Urgent Field Safety Notice

Subject: Progressa™ Bed Mattress—CLRT and Turn Assist Correction

FCA-identifier: Mod 1220

Affected Devices: Progressa™ Bed Mattress

Figure 1. View of Turn Assist Bladder

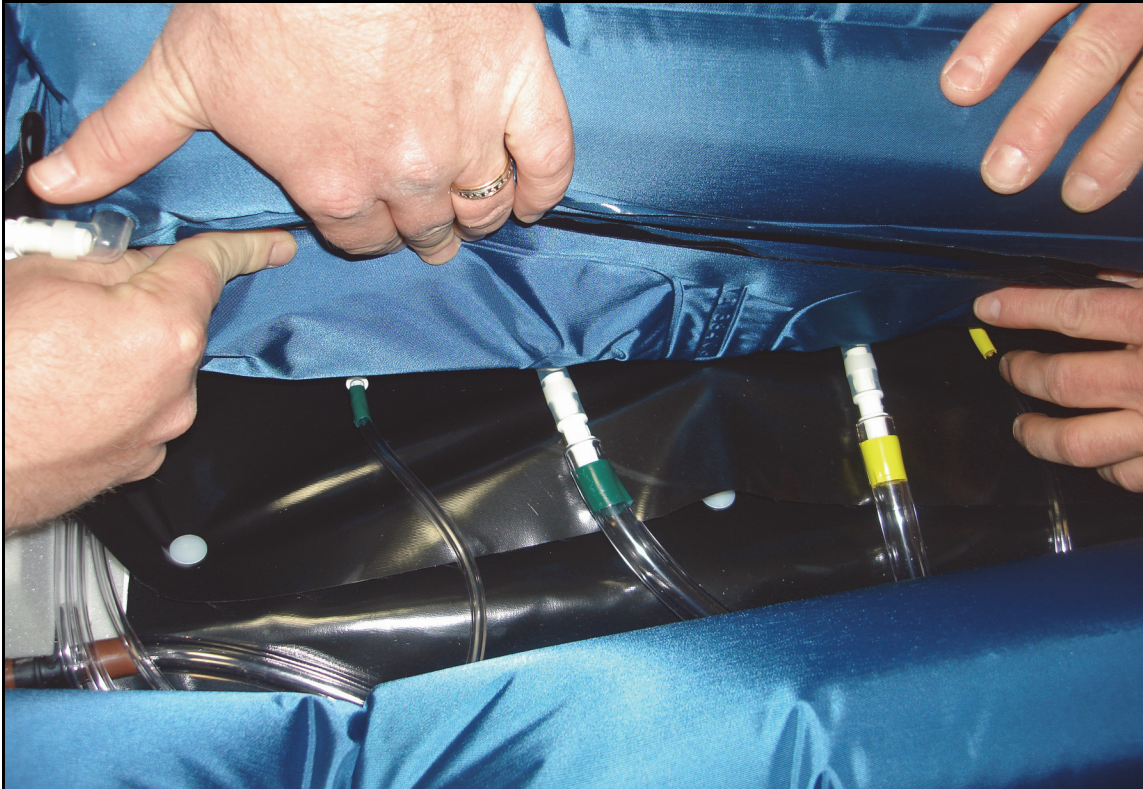
10. Pull the seat section away from the foot section to view the lower bladders (see figure 1 on page 2).

11. Remove and DISCARD the four snaps (2 on outer sides, 2 upper and lower middle) that attach the turn assist bladder to the substrate.
12. Slide the turn assist bladder out from under the support cushion, flip it over and onto the foot section (see figure 2 on page 3).
13. Disconnect the two fill hoses and two smaller sense lines from the couplers.
14. Remove and DISCARD the turn assist bladder.
15. Place the new turn assist bladder (marked **Rev 4**) from the kit onto the foot section in the same orientation.

Figure 1. USB Connector

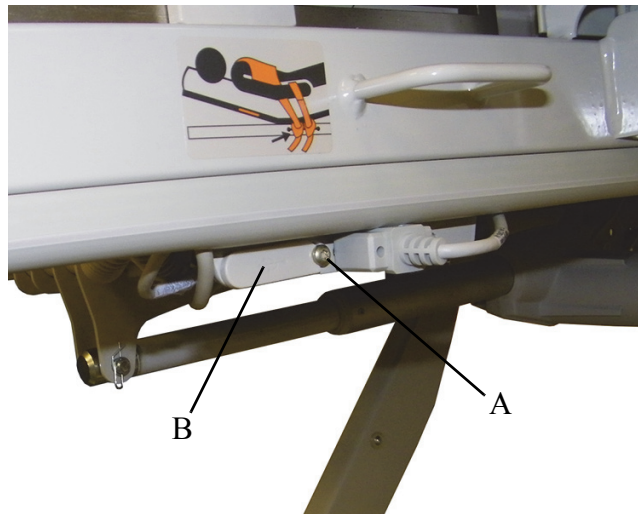
1. Raise the bed to the full up position.
2. Make sure the brakes are set.
3. Make sure the patient is not on the bed.
4. Make sure the bed is connected to AC power.
5. Make sure the GCI is active.
6. On the patient-right side of the bed, next to the pendant connector, remove the screw (A) and USB connector cover (B) (see figure 1 on page 1).
